**CITY OF CENTRAL POINT  
PLANNING COMMISSION AGENDA  
November 5, 2019 - 6:00 p.m.**

SITE PLAN AND ARCHITECTURAL REVIEW - PREMIER OIL

Consideration of a Site Plan and Architectural Review application for the development of a 2,345 square foot oil change facility and a 4,971 square foot automated car wash, including parking, payment kiosks, vacuum stations and landscape areas. The project site is located at 4245 Table Rock Road within the Tourist and Office Professional (C-4) zoning district and is identified on the Jackson County Assessor's map as 37S 2W 01C Tax Lot 700. **Applicant:** JB Steel, Inc.; **Agent:** Amy Gunter; Rogue Planning & Development Services, LLC.

**EAST ELEVATION**

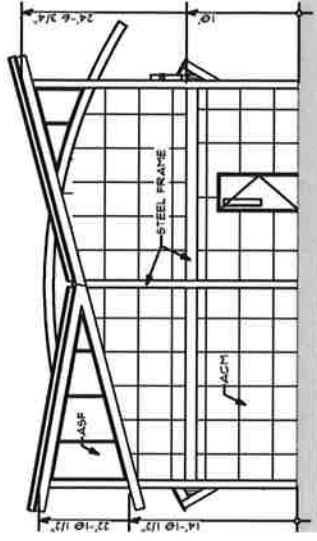
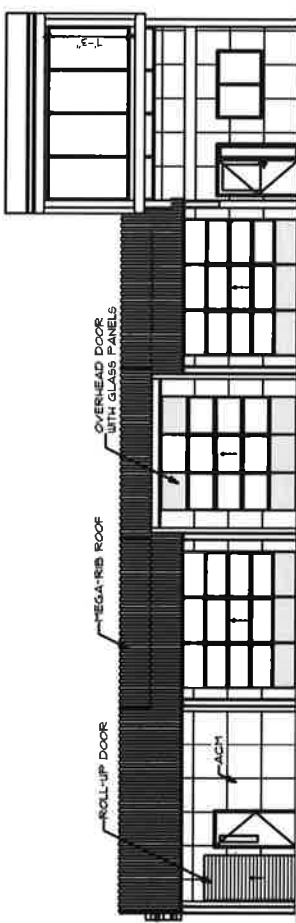
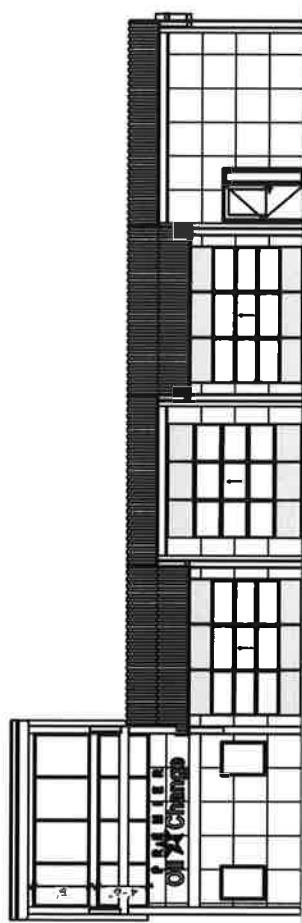
**4) Building Design Standards:** Modifications to the proposed elevations have been made which provide more pedestrian scale building façade using articulation of the street facing facades, and transparency with additional business entry doors and windows.

**Façade Wall Face:** The Biddle Road façade is the primary street façade. In addition to the transparent roll-up garage doors, a commercial style aluminum door is proposed to be added.

Two transom windows were added to the east side of the oil bay garage doors. Along the front façade, painted beams that extend beyond the face of the structure are proposed.

**PROJECT TITLE:**  
Landscape Plan

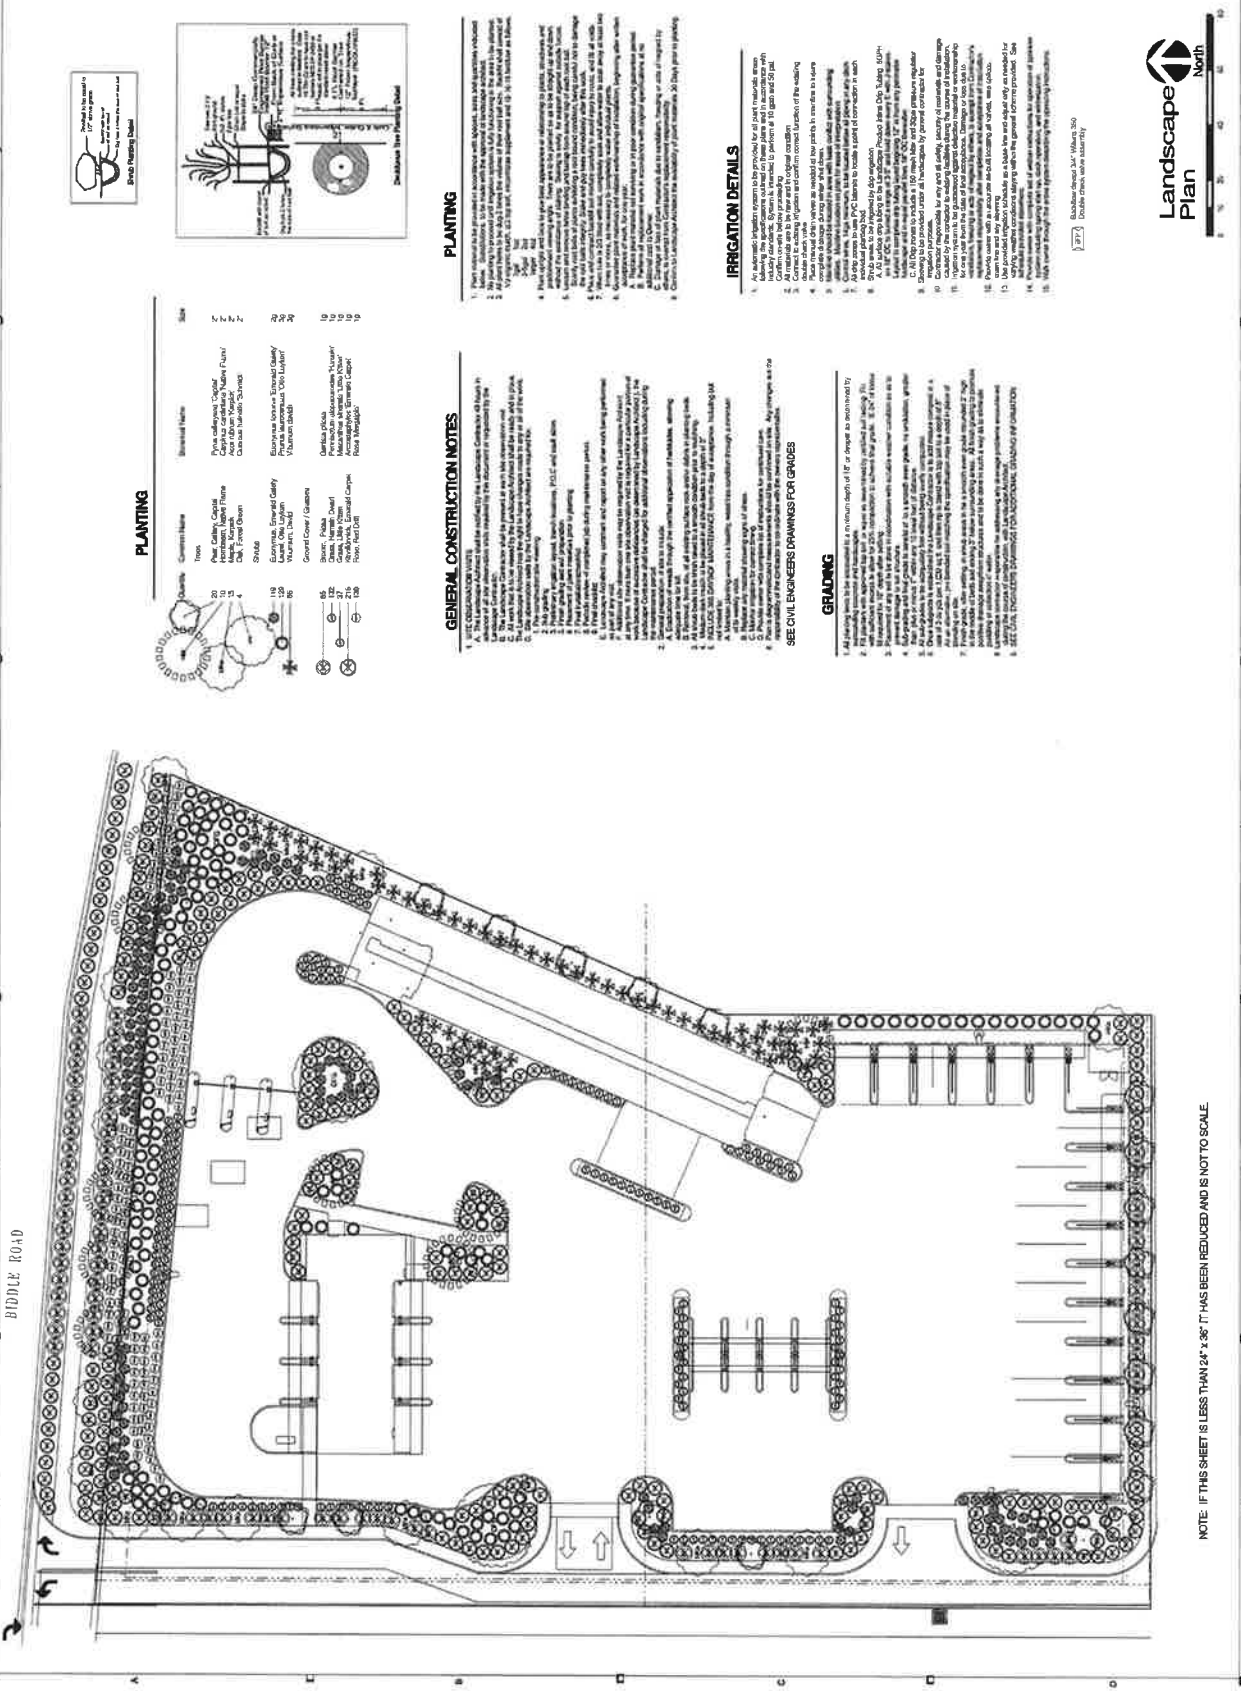
2. **Building Design (Pedestrian Entrance).** The proposed building design for the oil change facility fronts Biddle Road and does not meet the Pedestrian Entrance designs standards in CPMC 17.75.042(A)(3). A commercial building facing a street is required to provide a primary pedestrian entrance that is easily visible or accessible from a street or other pedestrian access. The front façade of the oil change structure identifies the pedestrian entrance with a door and sidelight window and a metal overhang that differs in color from the overhangs over the bay doors. The Applicant’s findings (Attachment “B-2”) also describe a landscape area with customer seating.

**Comment:** To meet the Pedestrian Entrance building design requirements in CPMC 17.75.042(A)(3), the design of a front building facade must incorporate three (3) elements to achieve the objectives of providing a pedestrian entrance. The proposed design incorporates two

(2) design elements and describes a final element to demonstrate compliance with this section. Staff recommends Condition of Approval No. 1(B) requiring a revised site plan and landscape plan that depict the proposed landscaping and furniture for the customer seating.

- b. Provide a revised site plan and landscape plan that depicts the landscaped seating area at the west side of the front façade of the oil change structure that includes, but is not limited to, the location and type of landscape, ground cover materials and furniture proposed to comply with the requirements of CPMC 17.75.042(A)(3), Pedestrian Entrances.
